## CLEARFIELD CITY PLANNING COMMISSION MEETING AGENDA

# Planning Commission STAFF REPORT

SUBJECT: Discussion and Possible Action on SP 2025-0601, a site plan request by Design

Project Information
Project Name	Monument Motors
Site Location	460 West 1700 South
Tax ID Number	12-065-0203
Applicant	Design West Architects
Owners	Lundock Deets LLC
Proposed Actions	Site Plan Approval
Current Zoning	C-2 (Commercial)
General Plan Land Use Classification	Commercial
Gross Site	1.87 Acres

ELEVATIONS -EXTERIOR

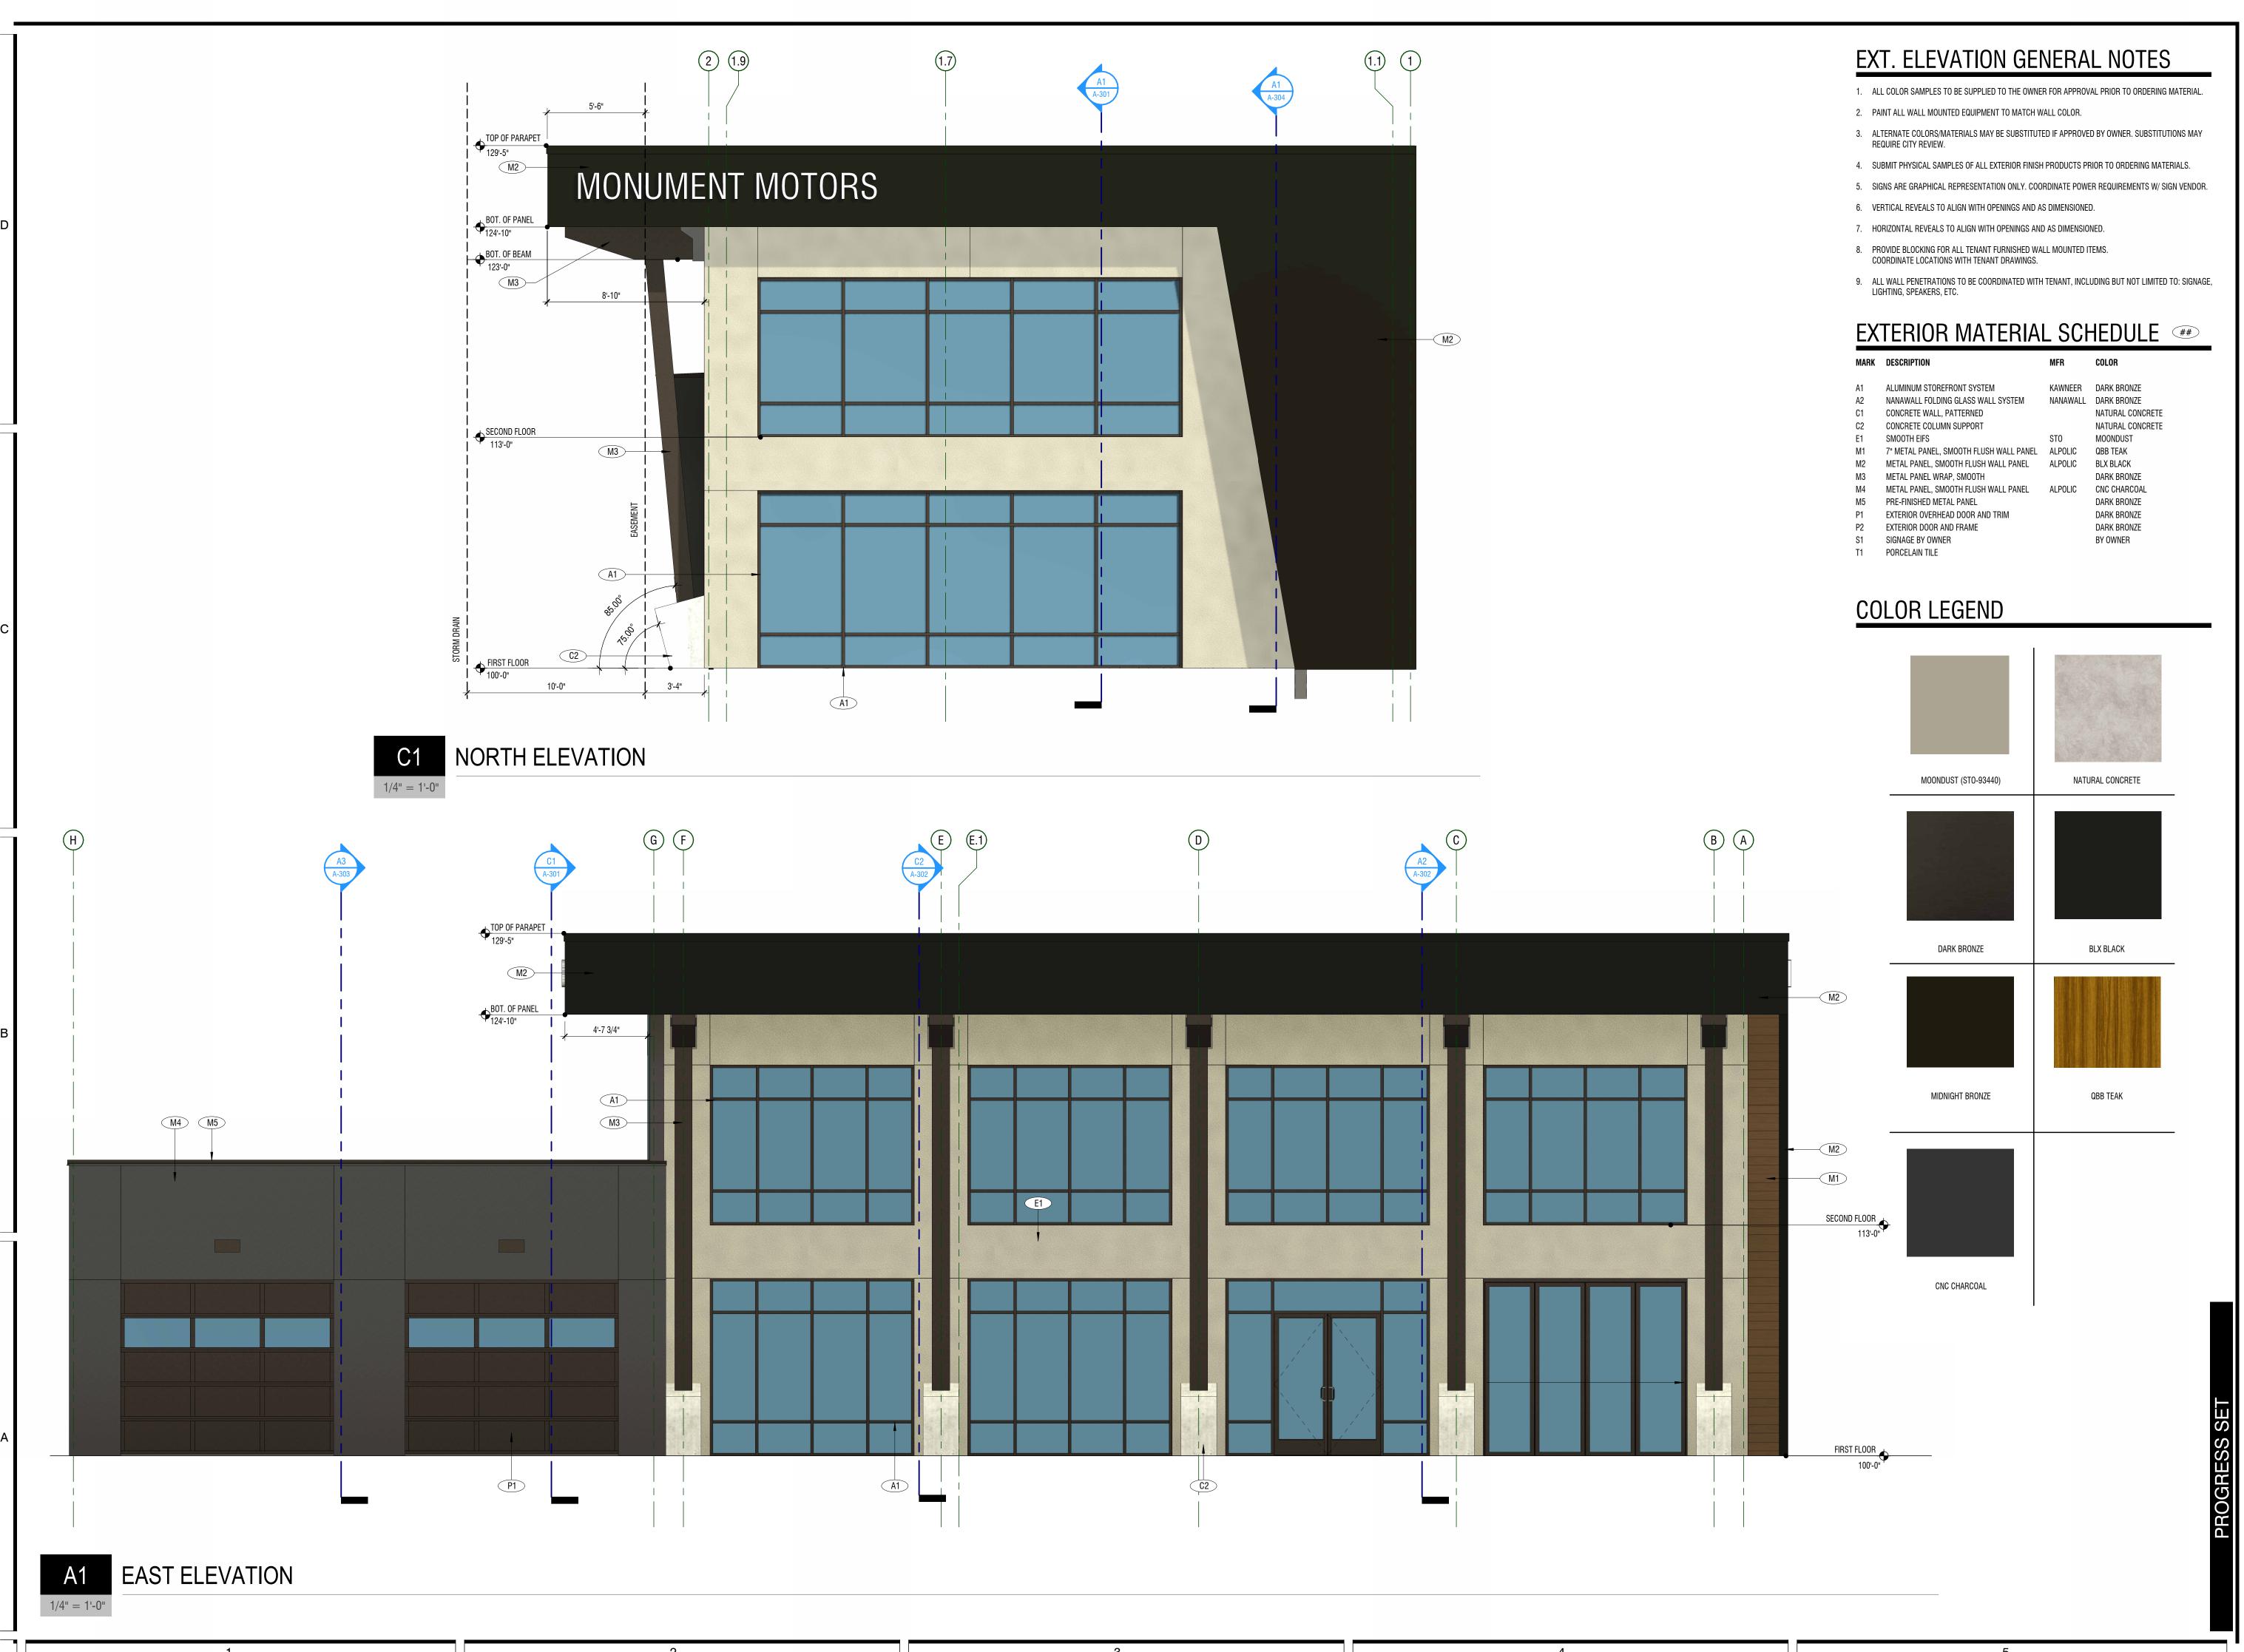
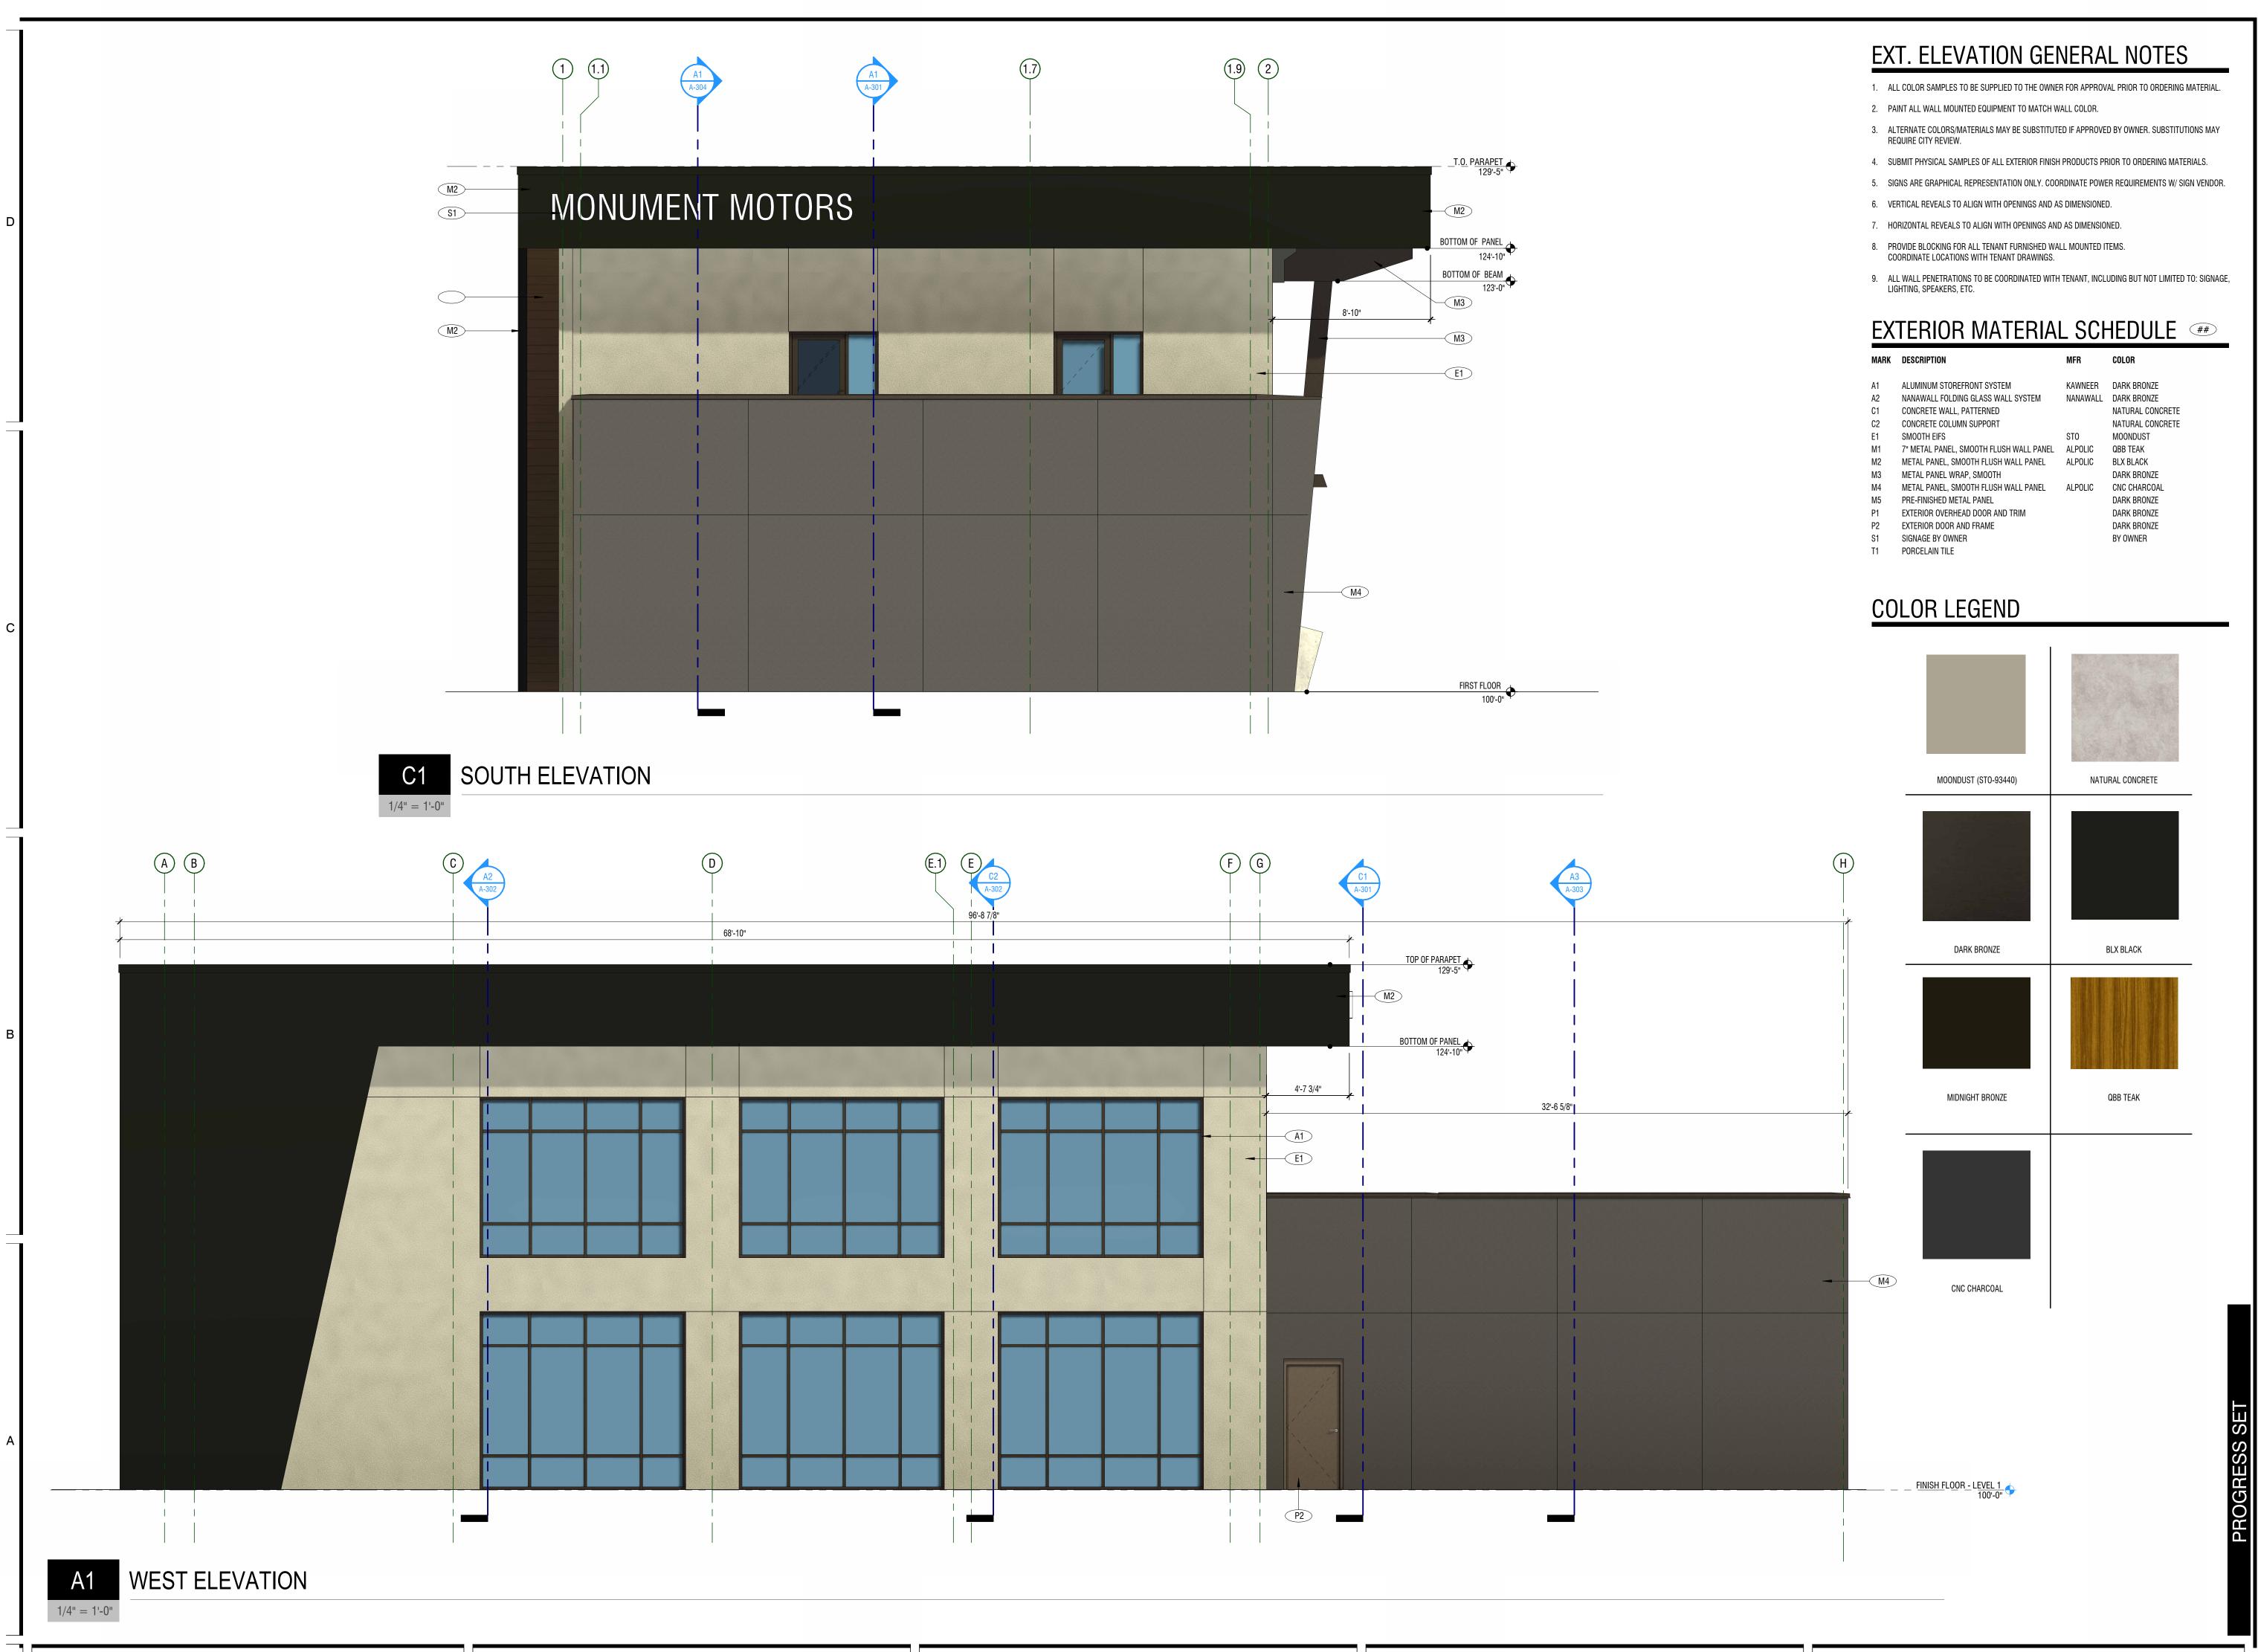
The C-2 Zone has specific architectural standards for Motor Vehicle Sales establishments, intended to create buildings that have detailed elevations with human scale and interest through the varied use of forms, materials, details, and colors. Specifically, an increased use of windows is required for street facing facades. Staff recommends that the applicant review the window standards for street facing facades and add some type of window treatment to the south façade of the vehicle pick up bays.

- 4) The plans will need to be updated to include an increased use of windows on the south façade, along the vehicle pick up bay portion of the building.
